MONTLAKE ELEMENTARY SCHOOL

Certificate of Approval Existing Tree Replacement April 03, 2025

Revisions to the approved C of A scope for removal and replacement of previously designated significant plantings.

HISTORIC STAIR SCOPE CHANGE

CONCRETE STAIR CONDITION AND CHANGE IN SCOPE FROM ORIGINAL C OF A PACKAGE:

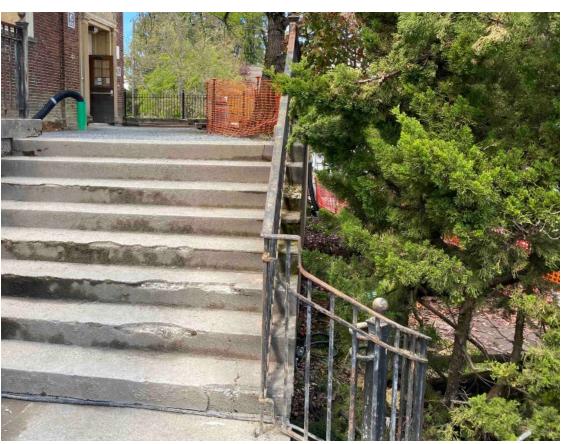
The concrete stairs were in fair condition prior to construction. Some areas of cracking and spalling were noted, but the preferred approach was to patch and repair the existing. DLR Group did note in their initial survey that these stairs had been re-surfaced in the past with a concrete topping over the original steps. The topping appeared to be holding in place for the most part with some areas of delamination noted at edges and nosings.

The existing wrought iron railings were in fair condition with the primary issues being weathered coatings in need of replacement. Some locations of localized oxidation were noted, but generally the railings appeared sound.

As construction progressed, regular foot traffic on the stairs exacerbated the delamination of the topping material. The decision was made to remove the existing stairs and replace them in-kind with new concrete steps. The existing railing was salvaged and re-installed per the details of this package and restored per the originally submitted "Metal Restoration" specifications.

REVISED LANDSCAPE DEMO

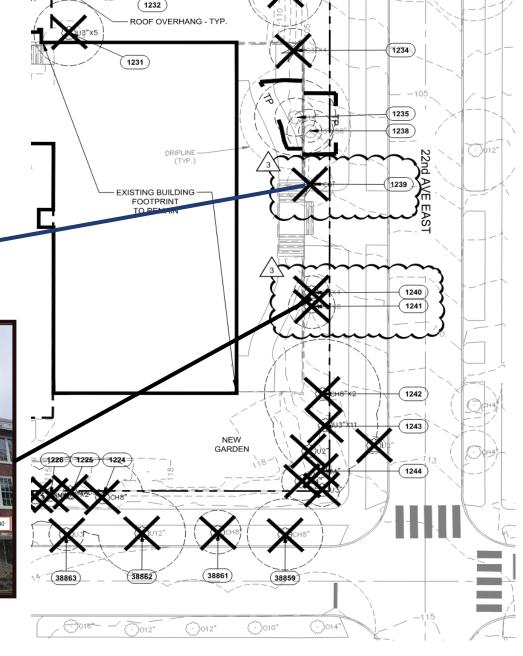
(1) Exceptional Tree removed

- Type: Chinese Juniper (Juniperus chinensis)
- Removal Reason: The exceptional tree needs to be removed due to its close proximity to work on the front stairs which would require removal of half of the tree canopy.

(1) Significant Tree removed

- Type: Photinia (Photinia x fraseri)
- Removal Reason: Tree was standing dead at time of arborist observation

(1) Unregulated Tree removed (less than 6" in diameter)

- Type: Photinia (Photinia x fraseri)
- Removal Reason: In poor structural health

Photo of existing trees, at time of construction

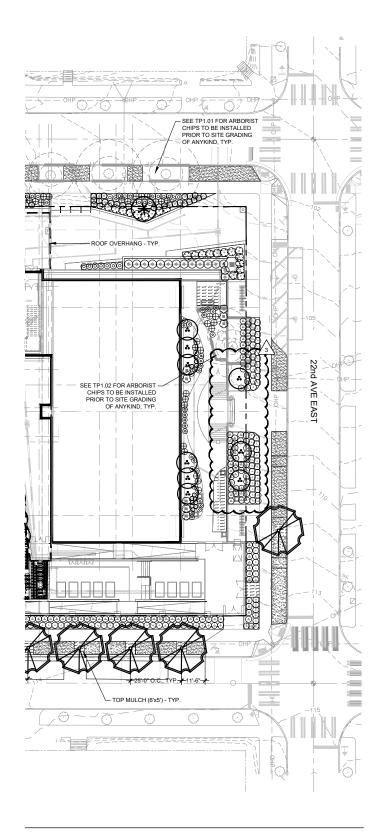
(3) New Vine Maple ('Acer Circinatum') are proposed to be planted on site as replacements for the (1) significant tree and (1) exceptional tree proposed to be removed.
